X244 ALL
Document Control Desk
Director of Nuclear Reactor Regulation
U.S. Nuclear Regulatory Commission
Mail Station PL-137
Washington, DC 20555

Attached is a revision to the Offsite Dose Calculation Manual, Dresden Annex, Chapters 10 through 12. Please update your manual as follows:

Dresden Station
Chapter 10 Change Summary
ODCM Revision 1.9, January 1997

Dresden Station
Chapter 11 Change Summary
ODCM Revision 1.2, January 1997

FIGURE 11-3

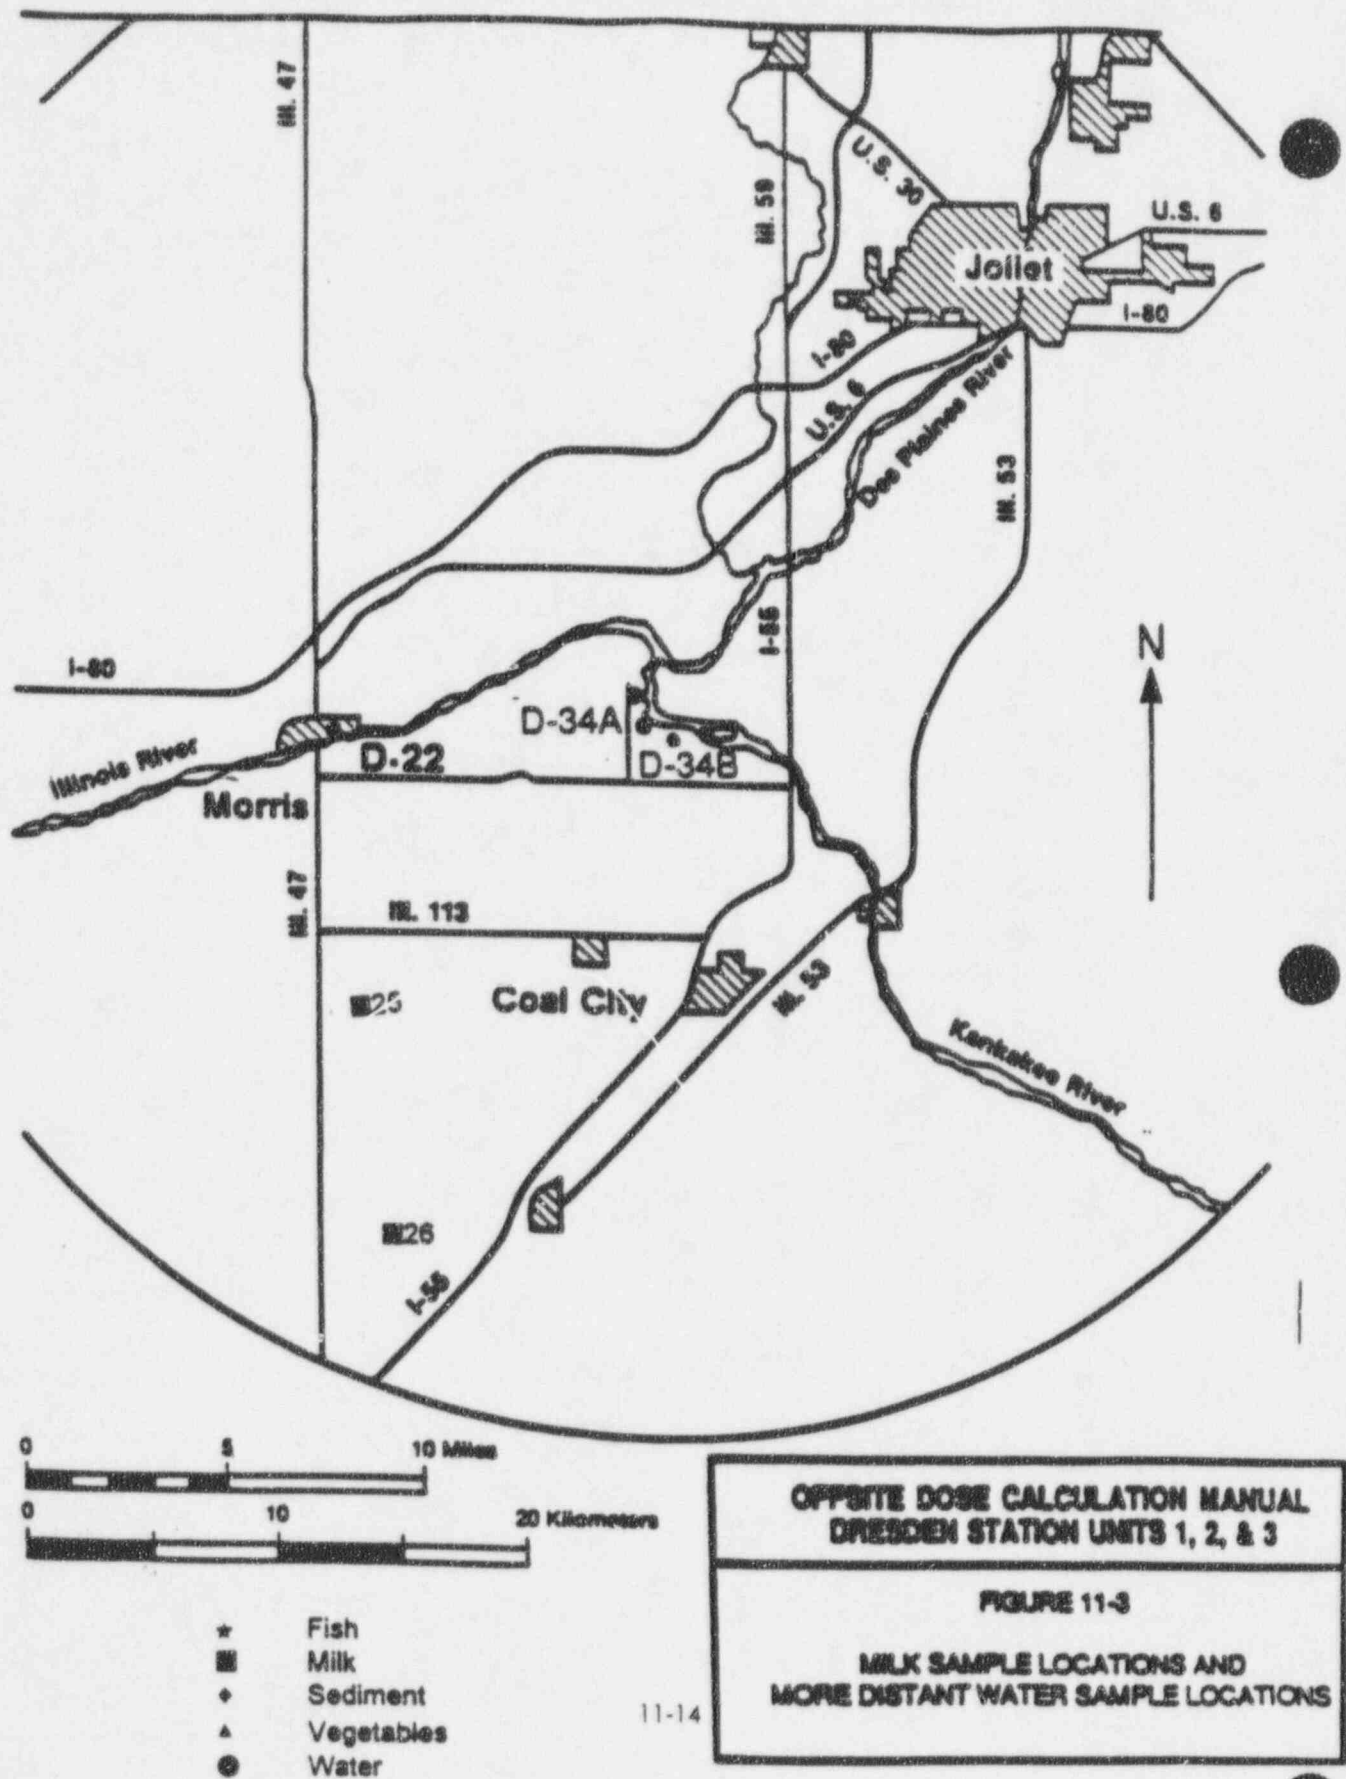
<u>Page</u>	<u>Item</u>
11-i	Removed page index. Individual pages no longer updated.
11-2	Removed D-05 and footnote. D-05 deleted in 1995 as indicated by the footnote. Removed asterisk by D-45 indicating it replaced D-05 in 1995.
11-3	Updated location of TLD's 110-3 and 110-4 to reflect current placement.
11-6	Added D-50 as a unit 2/3 Cooling Water Sample location.
11-7	Changed Director title due to new department responsibilities.
11-12	Deleted D-05 from map. Location no longer exists.
11-13	Added D-50 location due to new cooling water sample. Updated locations for TLD's 110-3 and 110-4 based on current location.
11-14	Removed an incorrect milk location from the map; two different locations were given on the map for D-26.
